Subject: Corrigendum on behalf of Thar Energy Limited for Modification of its Generation License

APPLICATION FOR MODIFICATION OF
GENERATION LICENSE NO. IGSPL/83/2017 DATED JUNE 07, 2017

ON BEHALF OF
THAR ENERGY LIMITED (TEL)

Dated 08 August 2023

Cold Start-up Load Profile (Synch to Full Load = 326 min)

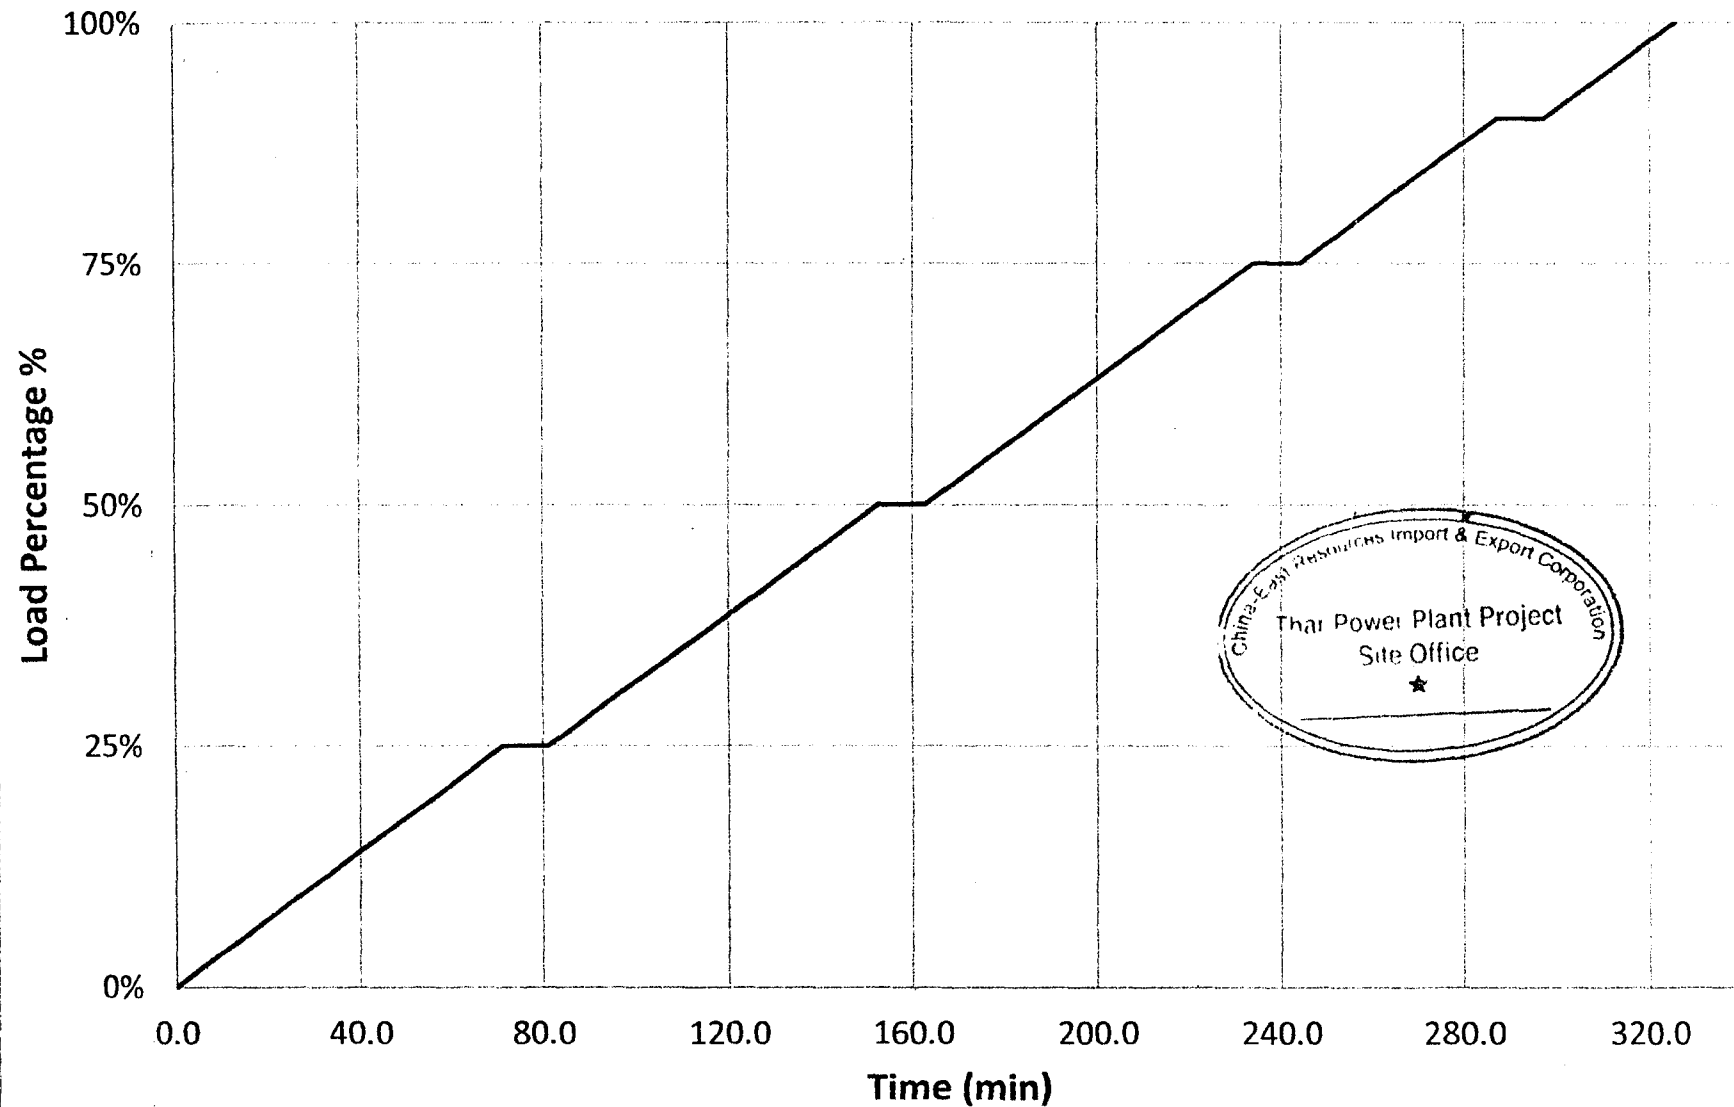
- In paragraph 2.1 of section 2 "*Proposed Modification*", table of ramping rate has been modified.
- In paragraph 3.1 *Rationale for the Modification to Ramping rate of section 3*, Hold Time and ramp rate of Warm Start has been modified.
- In paragraph 3.2 *Rationale for the Modification to the Time required for the Synchronization of the Grid*, section has been revised based on the Startup curves provided by OEM.

- e. Based on recent operational experience of CFB boiler at TEL plant and operational practices of other plants of similar technology, Hold Time is added after every step load change and ramp rate for Warm Start is changed, for normalizing the operational parameters like furnace pressure, steam pressure, steam temperature and to avoid any undue stresses on the machine. Thermal stresses were quite evident and seen on different parts of the CFB boiler during recent planned outage of TEL plant, therefore, the above-mentioned changes are done per OEM/EPC recommendations, to avoid any damage to plant machinery.

Complex NET load range % age	Cold Start (% / Min)	Warm Start (%/Min)	Hot Start (% /Min)
<u>0 – 25 %</u>	<u>0.35</u>	<u>0.67</u>	<u>1.00</u>
Hold Time	10 minutes		
<u>25 – 50 %</u>	<u>0.35</u>	<u>0.67</u>	<u>1.00</u>
Hold Time	10 minutes		
<u>50 – 75 %</u>	<u>0.35</u>	<u>0.67</u>	<u>1.00</u>
Hold Time	10 minutes

<u>75 – 90 %</u>	<u>0.35</u>	<u>0.67</u>	<u>1.00</u>
Hold Time	10 minutes		
<u>90 – 100 %</u>	<u>0.35</u>	<u>0.67</u>	<u>1.00</u>
<u>Total Time</u>	<u>326 minutes</u>	<u>189 minutes</u>	<u>140 minutes</u>

TEL 1*330MW CFPP - Cold Startup Curve after 150 Hours (100% MCR, Performance Coal)

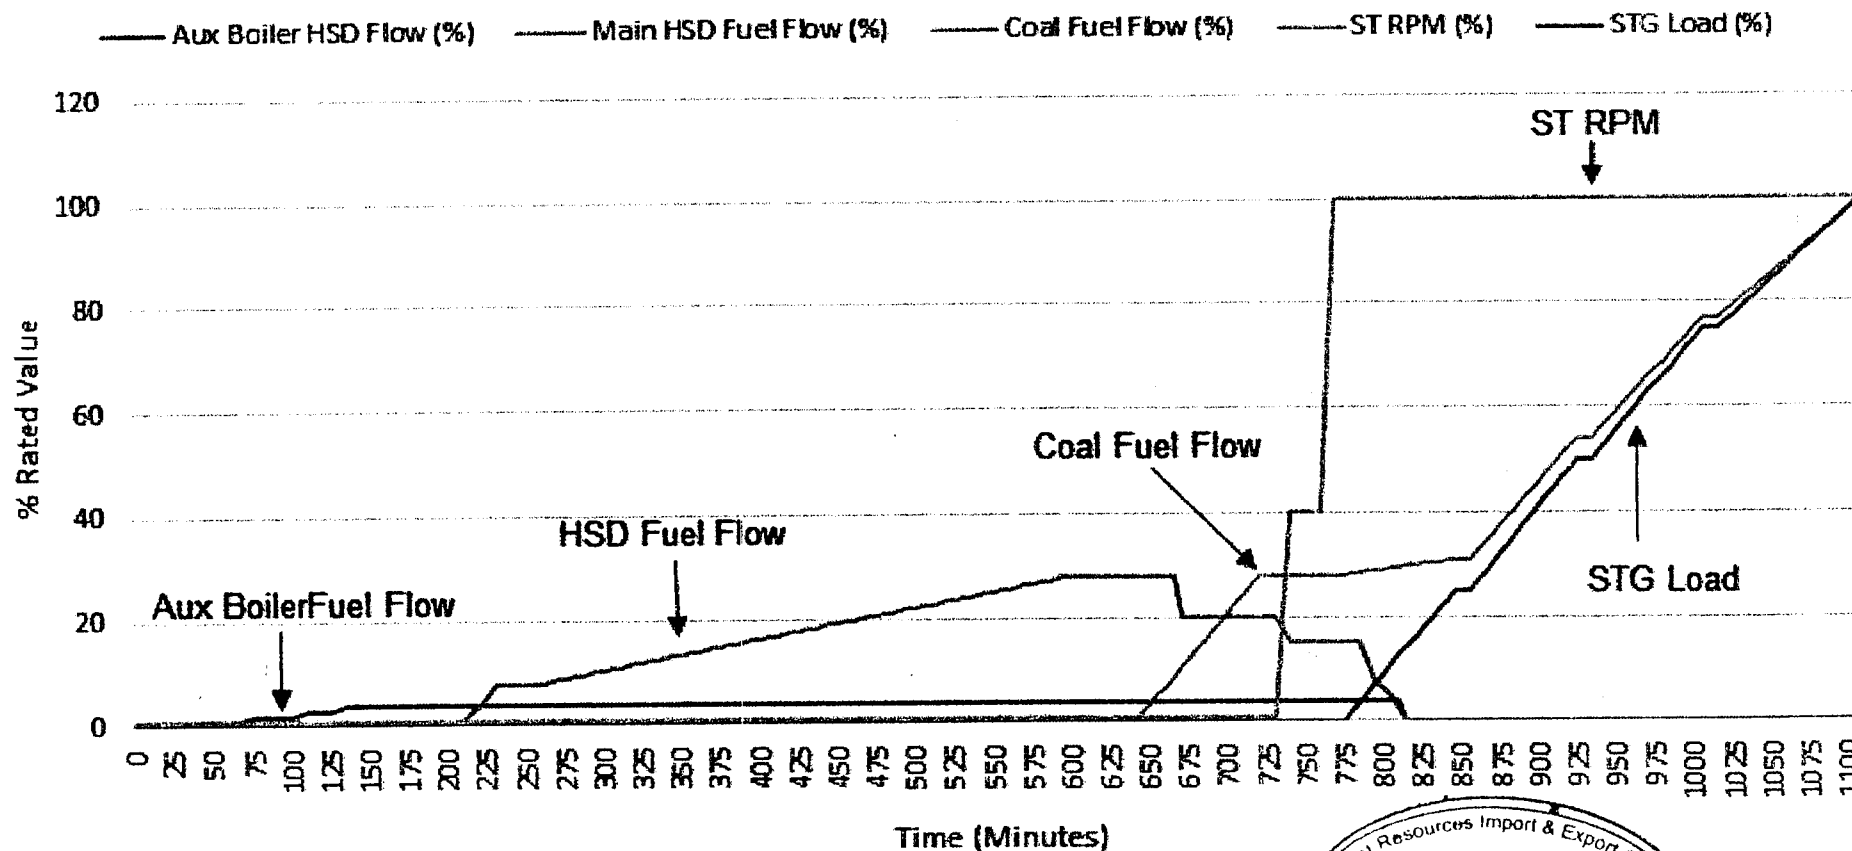
More than 150 hours: Total 770 Minutes, wherein, 200 minutes are required auxiliary boiler start and auxiliary steam system warm up, as well as for boiler water purity & pressure raising; 500 minutes are required for CFB boiler to setup temperature and pressure after the successful ignition: hot flushing time of 30 minutes in addition to Boiler Startup time to achieve the steam purity is required; Then, 40 minutes are required for turbine rolling and synchronization to grid. Therefore total 770 minutes are required for unit startup.

Length of Shutdown	Notice Required to Synchronize (The time start after boiler ignited)
Not more than 2 hours	100 min
More than 2 hours but less than 8 hours	150 min
More than 8 hours but less than 32 hours	360 min
More than 32 hours but less than 150 hours	550 min
More than 150 hours	770 min

TEL 1*330MW CFPP Warm-2 Startup Curve after 32 hrs & less than 150hrs (100% MCR, Performance Coal)

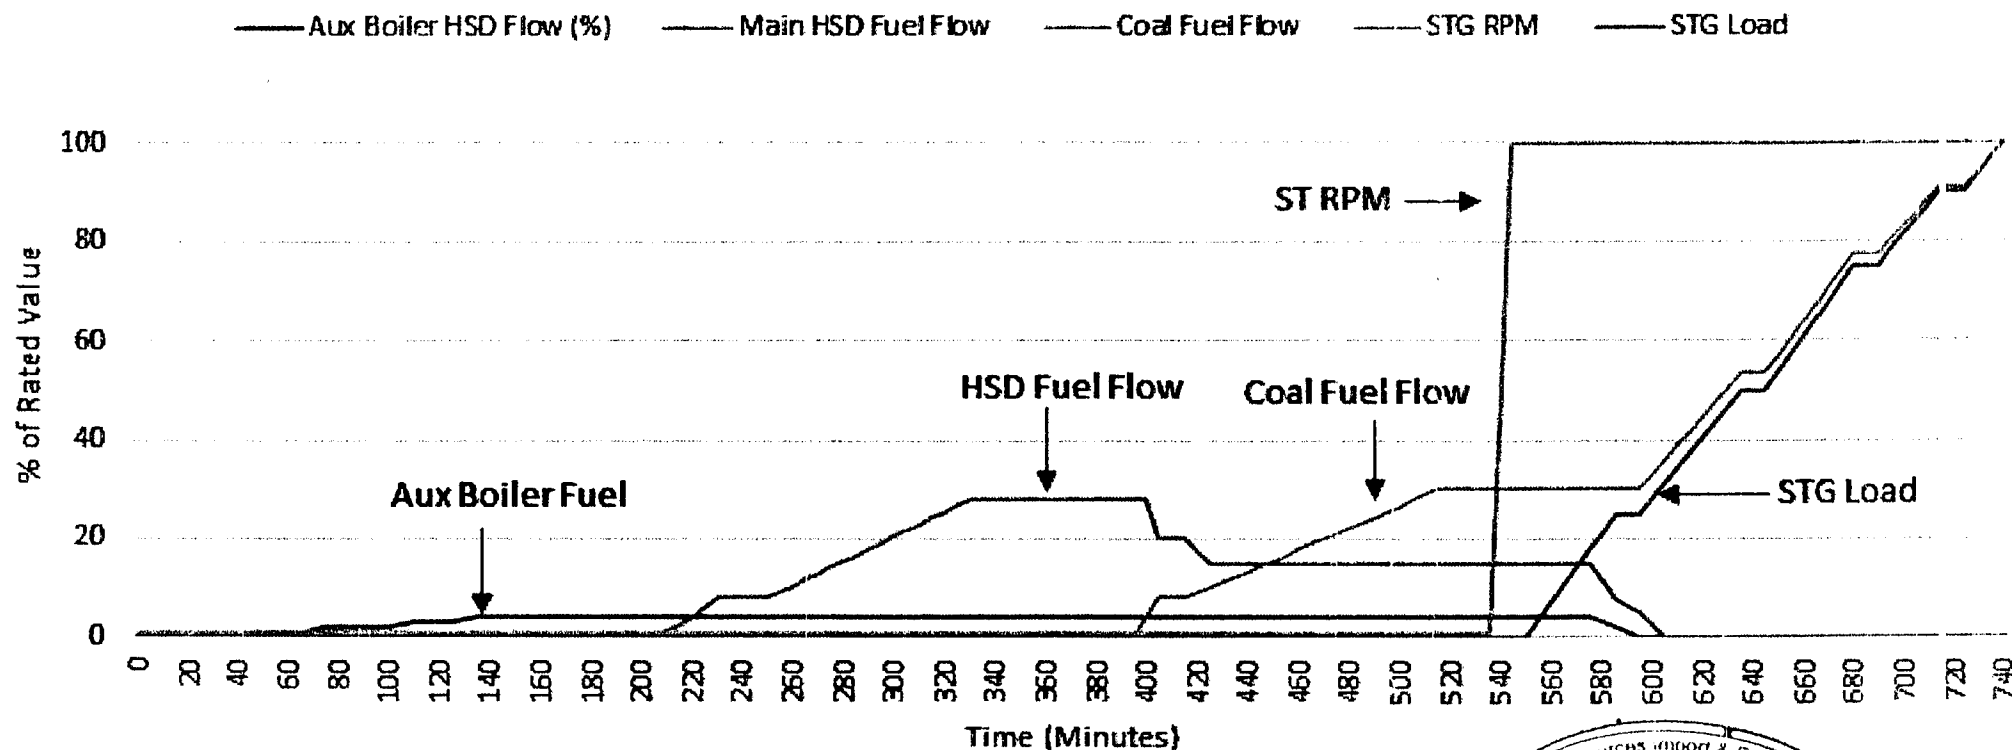
More than 32 hours and less than 150 hours: Total 550 Minutes wherein 200 minutes are required for auxiliary boiler start and auxiliary steam system warm up, as well as for boiler water purity & pressure raising, 290 minutes are required for CFB boiler to setup temperature and pressure after the successful ignition: hot flushing time of 30 minutes is needed; Then, 30 minutes are required for turbine rolling and synchronization to grid. Therefore total 550 minutes are required for unit startup.

TEL 1*330MW CFPP Warm-1 Startup Curve after 8 hrs & less than 32 hrs (100% MCR, Performance Coal)

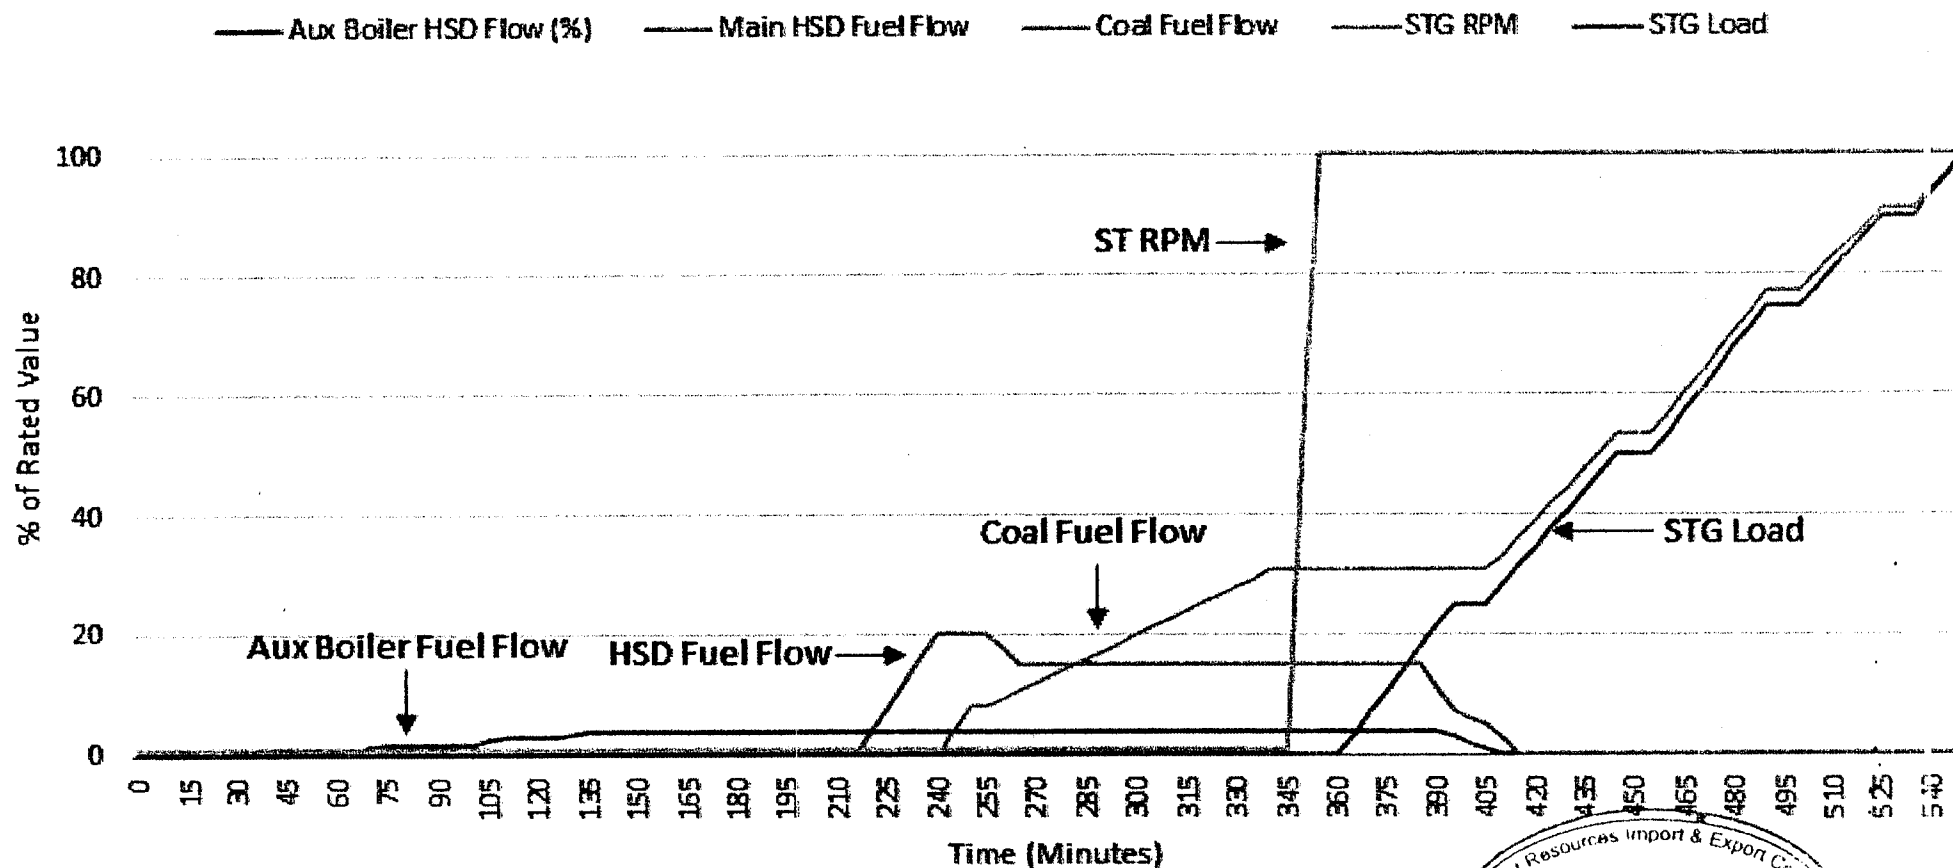
More than 8 hours and less than 32 hours: Total 360 Minutes wherein 200 minutes are required for auxiliary boiler start and auxiliary steam system warm up, as well as for boiler water purity and pressure raising; 145 minutes are required for CFB boiler to set up temperature and pressure after the successful ignition; Then, 15 minutes are required for turbine rolling and synchronization to grid. Therefore total 360 minutes are required for unit startup.

TEL 1*330MW CFPP Hot Startup Curve after 2 hrs & less than 8 hrs (100% MCR, Performance Coal)

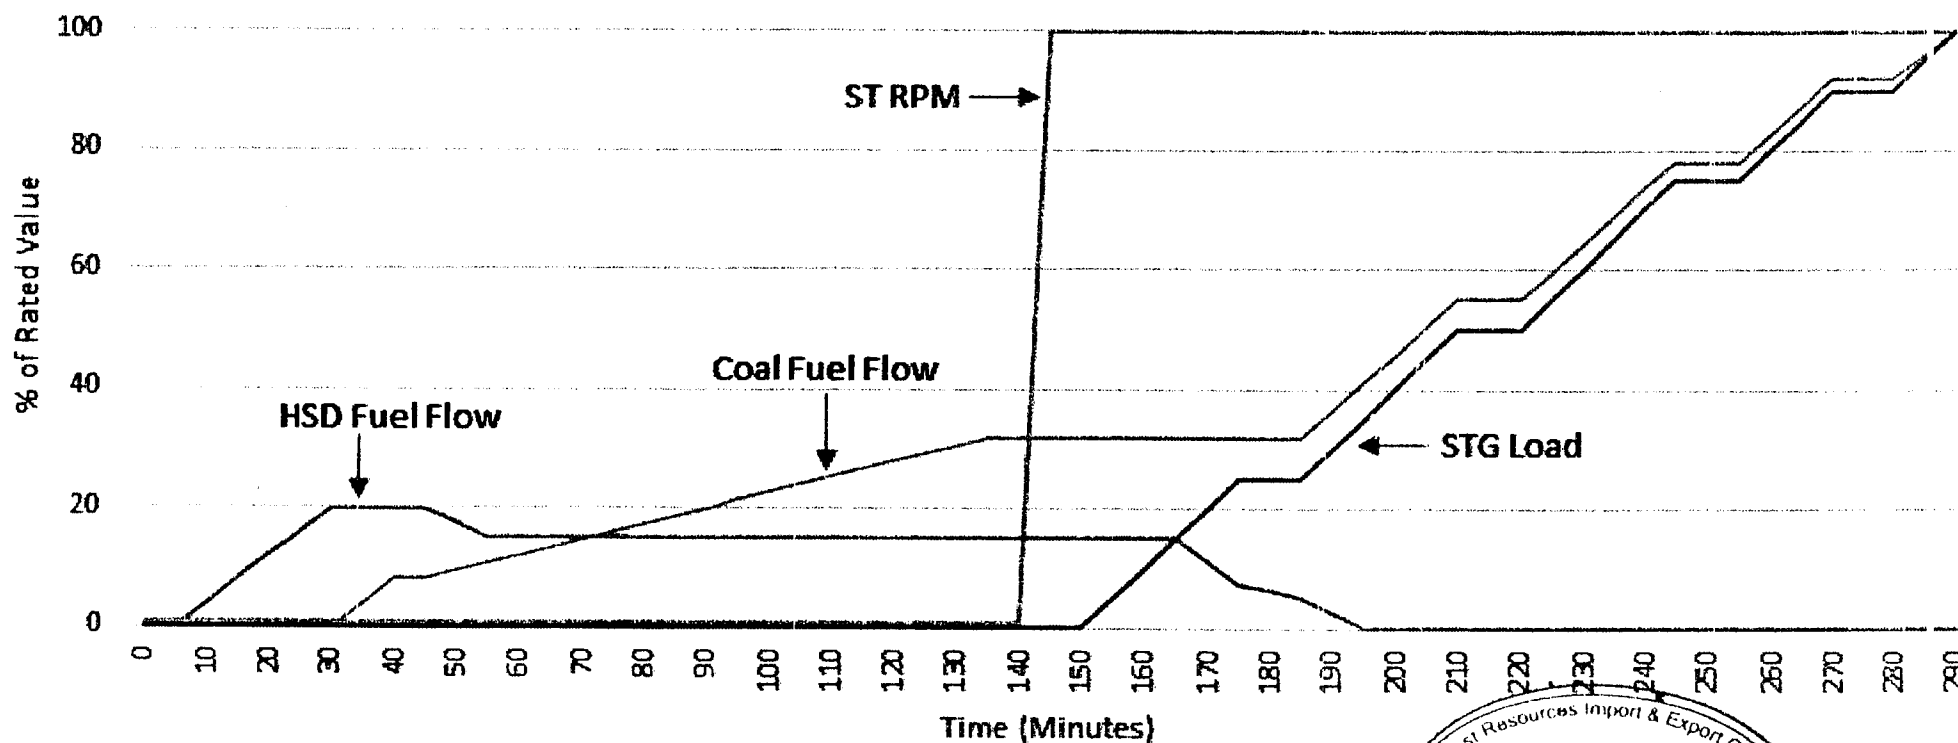
More than 2 hours less than 8 hours: Total 150 minutes, wherein 135 minutes are required for CFB boiler to set up temperature and pressure after the successful ignition; Then, 15 minutes are required for turbine rolling and synchronization to grid. Therefore, total 150 minutes are required for unit start-up.

TEL 1*330MW CFPP Very Hot Startup Curve less than 2 hours (100% MCR, Performance Coal)

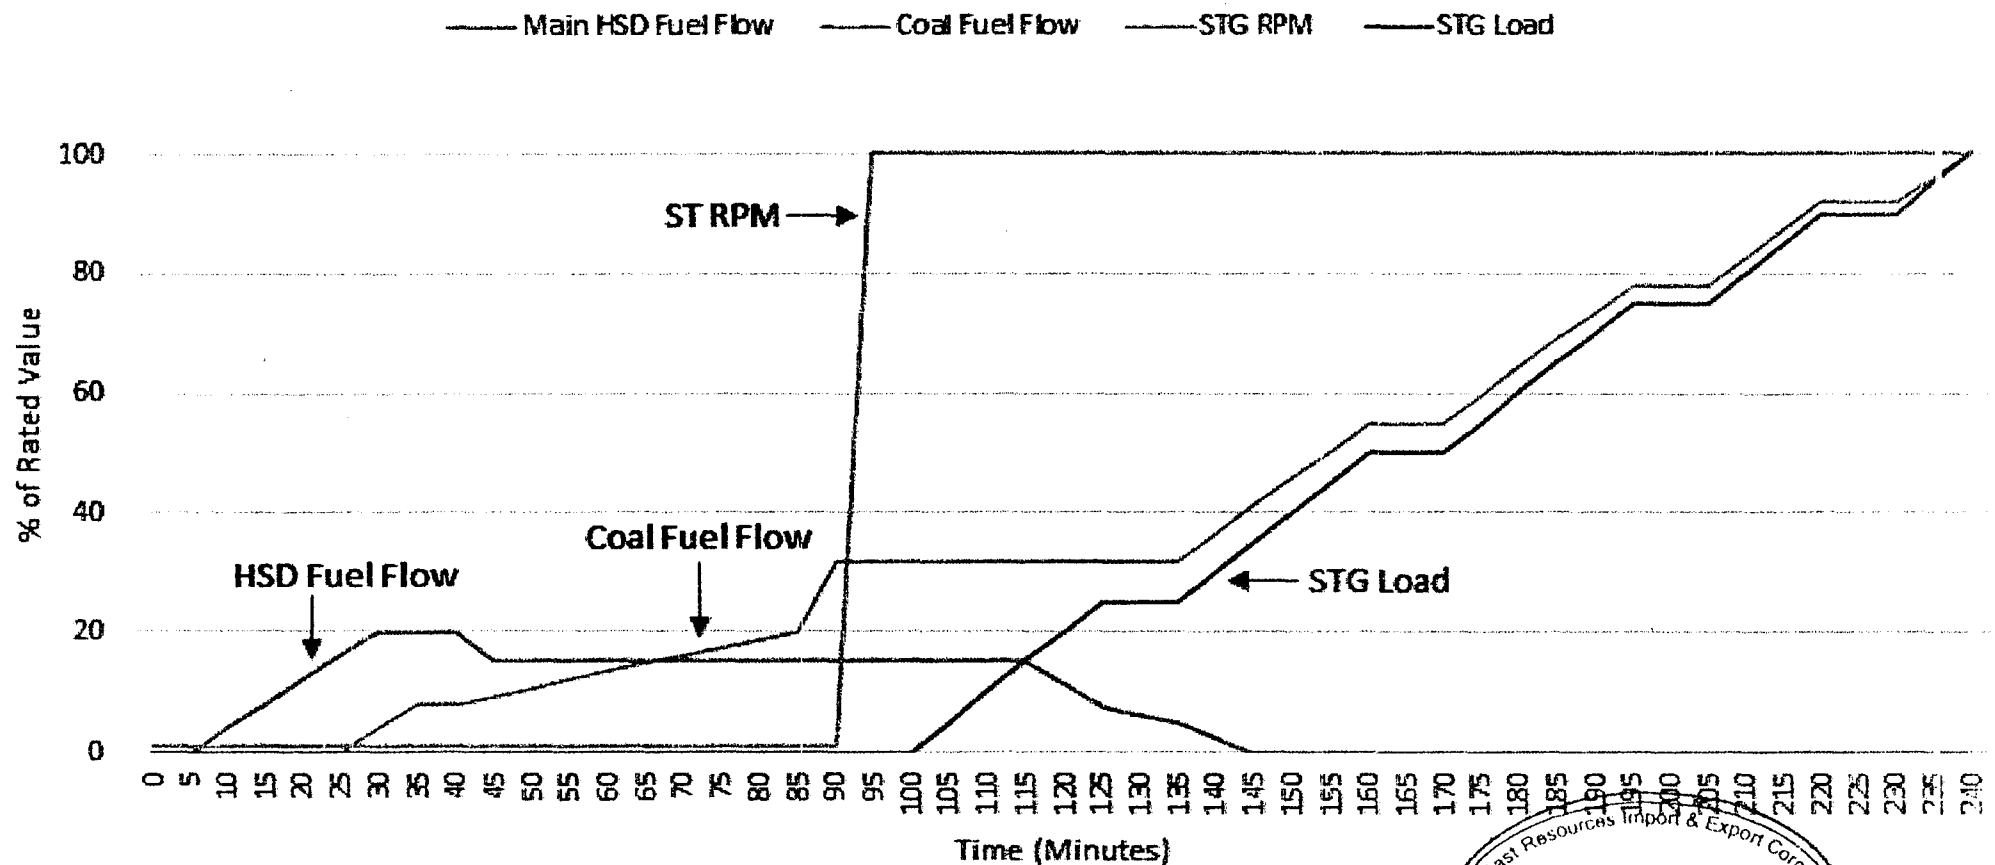
Not more than 2 hours: Total 100 minutes, wherein 85 minutes are required for CFB boiler to set up temperature and pressure after the successful ignition; Then, 15 minutes are required for turbine rolling and synchronization to grid. Therefore, total 100 minutes are required for unit start-up.
